RUSSELL VALE COLLIERY

Underground Expansion Project Response to Public Hearing

Wollongong Coal Limited

February 2015

Figure 1
Conceptual Water Balance for Cataract Reservoir (WCL, 2014)

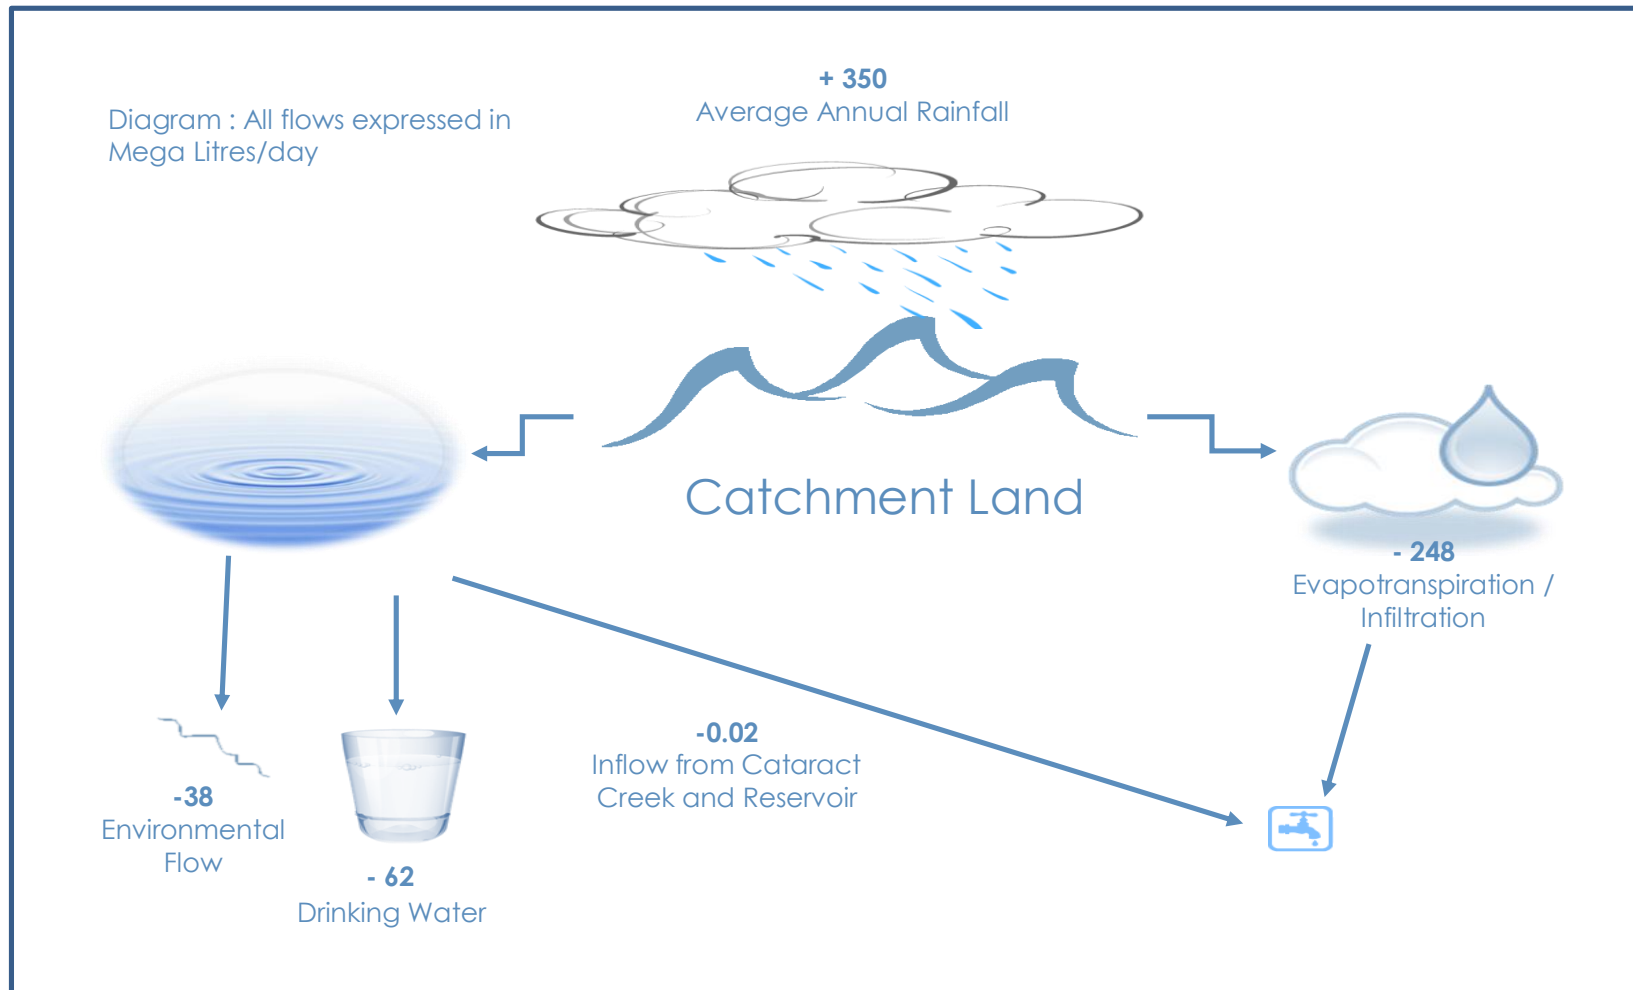
It was suggested that if impacts to Cataract Reservoir occur, a desalination plant would need to be constructed at great cost to the NSW taxpayer.

The mine plan for the UEP maintains a lateral setback from the full supply level (FSL) of Cataract Reservoir greater than 0.7 times the depth of cover (equivalent to a 35° angle of draw). Such a setback is considered by the DSC to be sufficient for protecting the stored waters of Cataract Reservoir.

The predicted reduction in storage in Cataract Reservoir due to the UEP is approximately 6.83 ML/year through reduced stream baseflow to the reservoir, and 1.83 ML/year through depressurisation affecting the reservoir (GeoTerra / GES, 2014). These losses represent 0.009% of the full storage capacity of Cataract Reservoir (97,190 ML). Due to the negligible magnitude of the impact, the construction of a desalination plant is not warranted.

Figure 1 shows a conceptual water balance diagram for the Cataract Reservoir catchment. Based on average annual rainfall, the catchment of Cataract Reservoir receives an average of 350 ML/day from rainfall. Of this amount, approximately 100 ML/day accumulates in the reservoir, where it is used to supply environmental flows or drinking water. The remaining 250 ML/day is lost from the water supply system through either evapotranspiration or infiltration into the groundwater system. The predicted inflows to the mine workings (up to 2.3 ML/day) are taken from the component of rainfall that is lost to infiltration. That is, mine inflows do not substantially affect the volumes of water that are available for water supply purposes or environmental flows.
